**AREA 2 FIELD SAMPLING PLAN**

**ADDENDUM TO REMEDIAL INVESTIGATION**

**FORMER FORT DEVENS ARMY INSTALLATION, DEVENS, MA**

**DECEMBER 2018**

Figure  
7

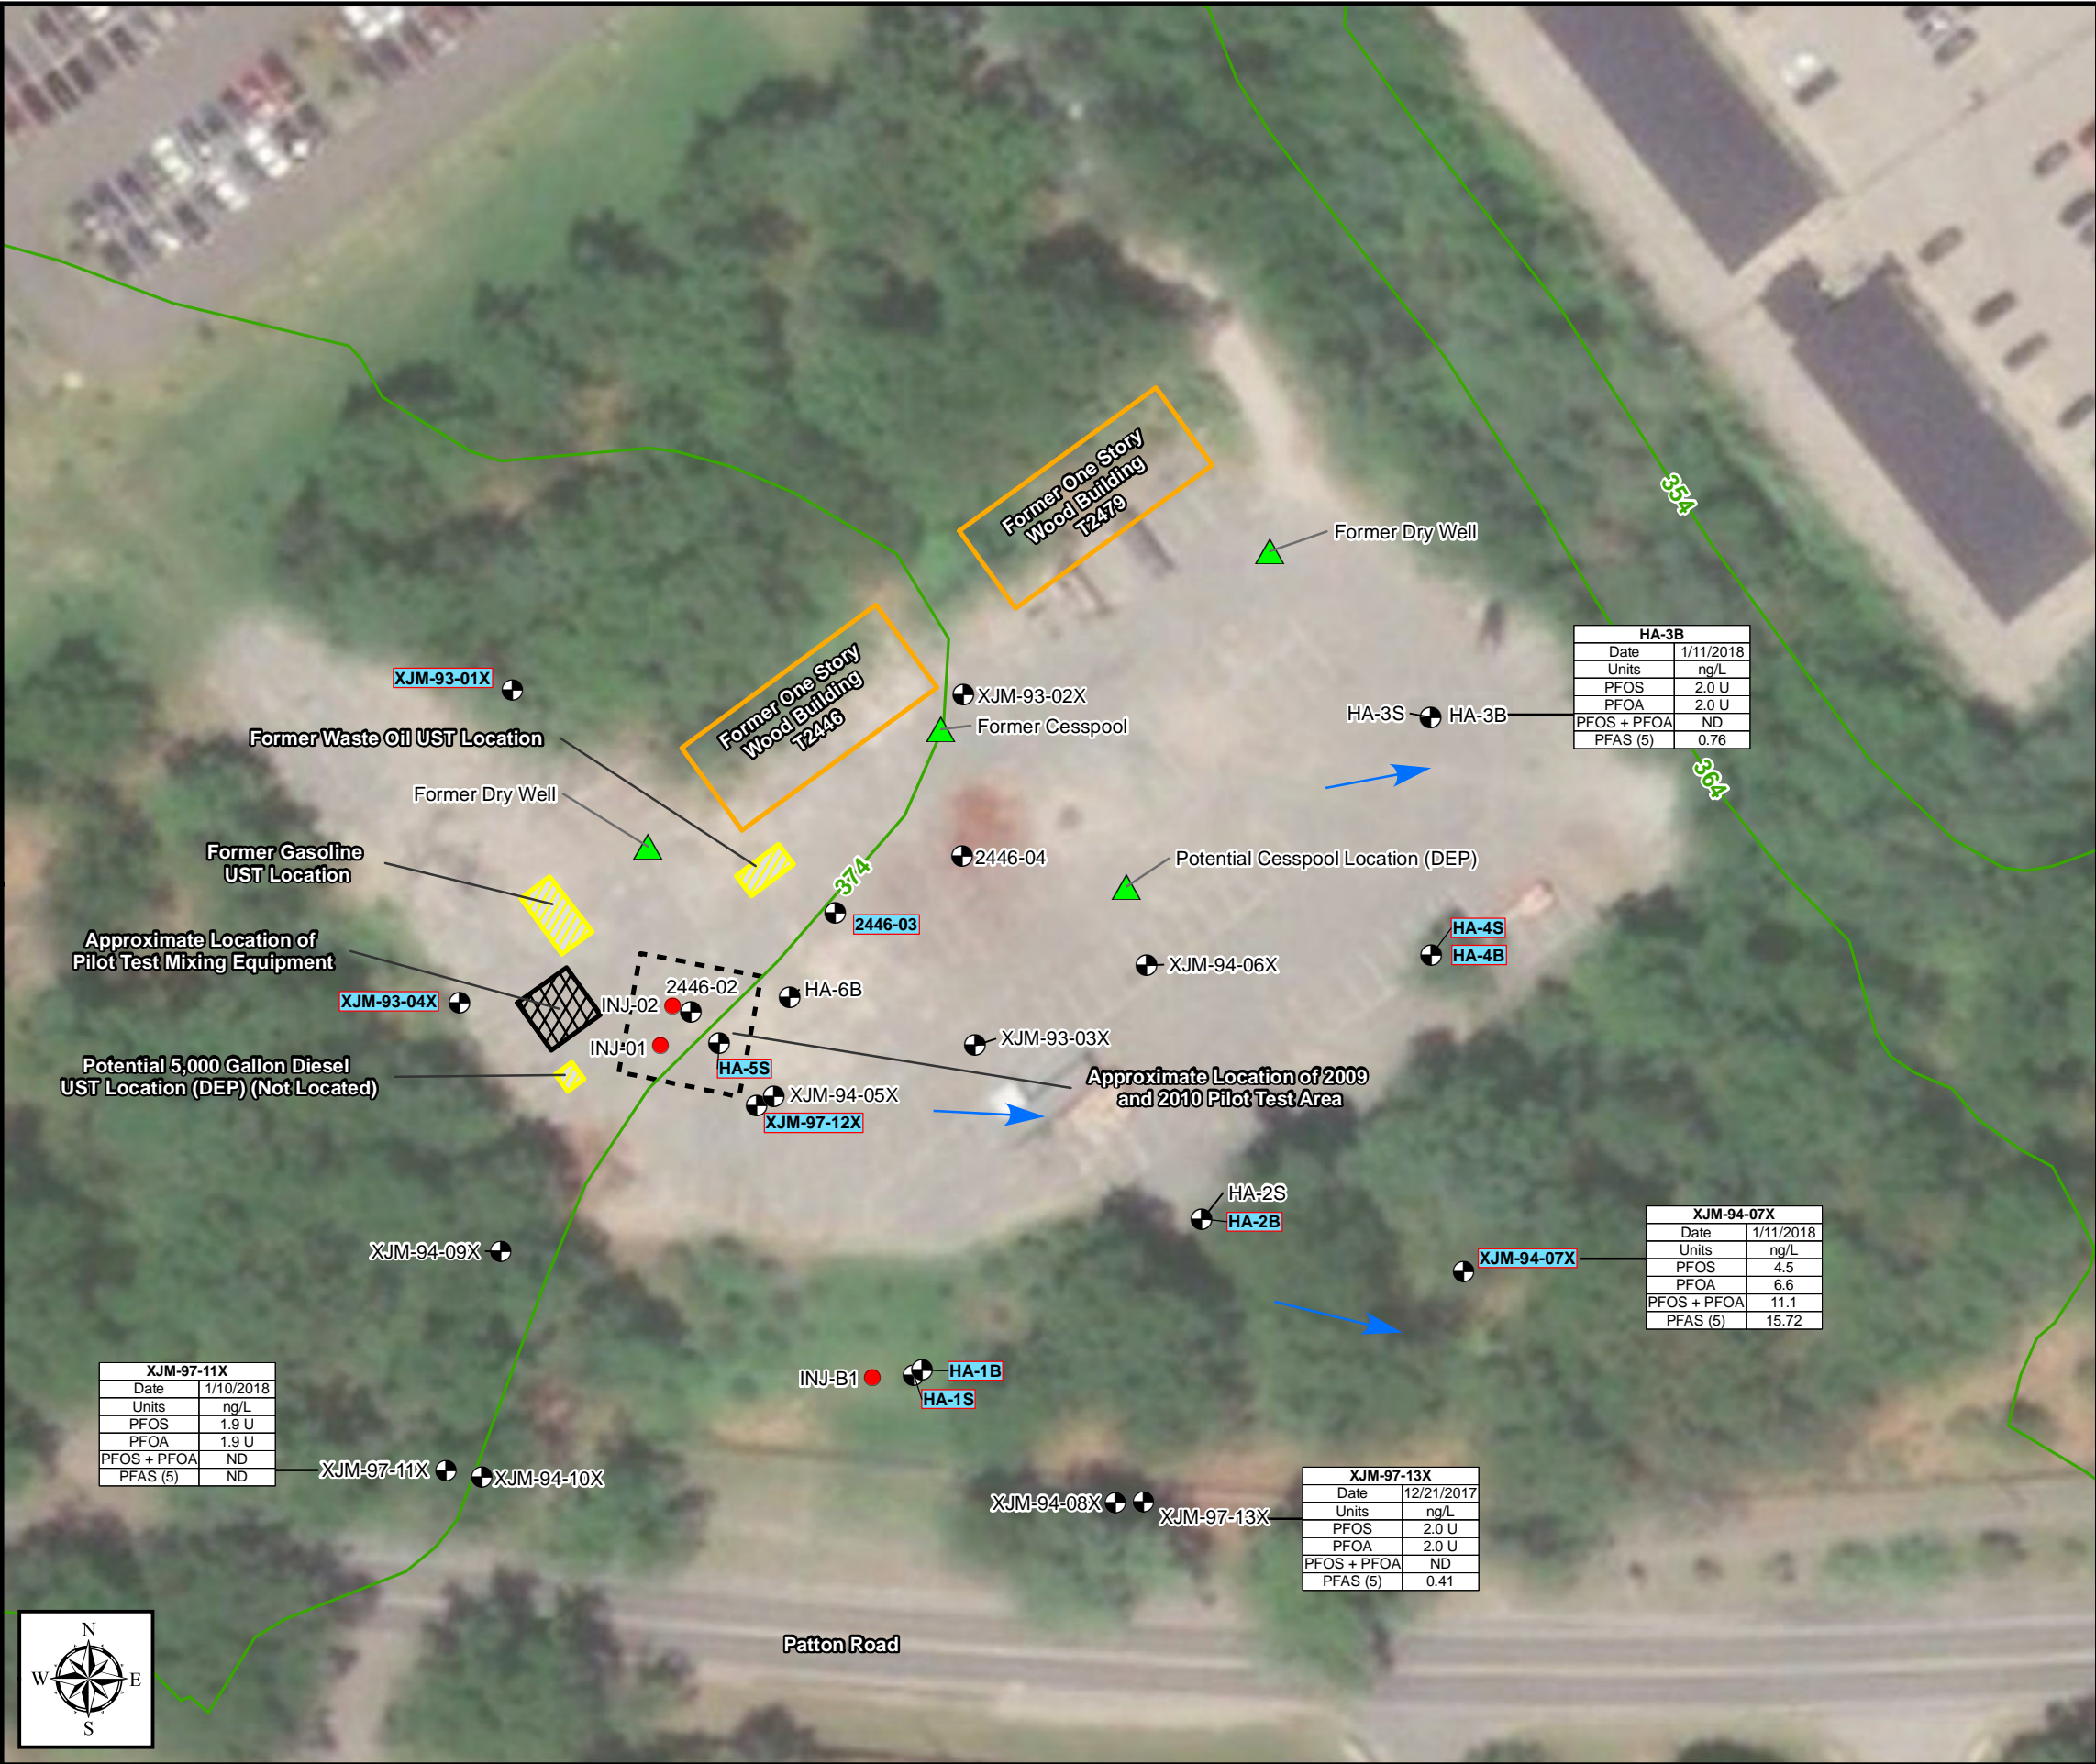
**Comment # 13:** Figure 7, AOC-43J – To better assess deeper groundwater, EPA requests that HA-2B be sampled if the well screen is deeper than XJM-94-07X (Table 4 lists the well screen for HA-2B as unknown, and the well screen for XJM-94-07X as 3.7-13.7 ft bgs).
